IMPORTANT IMMEDIATE ACTION REQUIRED

Corbin Motors has learned of a potentially dangerous situation that exists in some Sparrows. It involves the installation and position of the brake line and its proximity to the battery terminals. In the worst case this can cause a fire under the hood and brake failure.

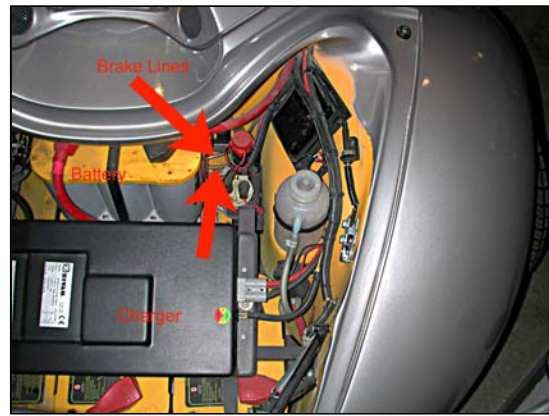
Why does this happen? Each time the brake is pressed the brake line fluid goes through the line and causes it to flex. Gradually, over time, this flexing can cause some of the loosely run brake lines to move next to the battery terminals. The brake lines are plastic-coated but the coating can gradually wear off and leave the metal brake line touching a battery terminal. This causes a short and the resulting electricity can cause the remaining coating on the brake line to burn off. This can result in a fire burning on the brake line plastic, damaging the brake lines and causing damage to the wiring system.

1. Open up the front hood of your Sparrow.
2. Using a flashlight, locate the two silver colored brake lines located behind and on either side of the battery, positioned against the firewall. Brake lines are indicated with the red arrows in the photos below. These brake lines are *not* secured against the firewall.

How can I prevent this from happening to my Sparrow? To ensure this situation does not occur, secure the brake cables to the firewall. Corbin Motors will send you a free, easy to install "repair" kit.
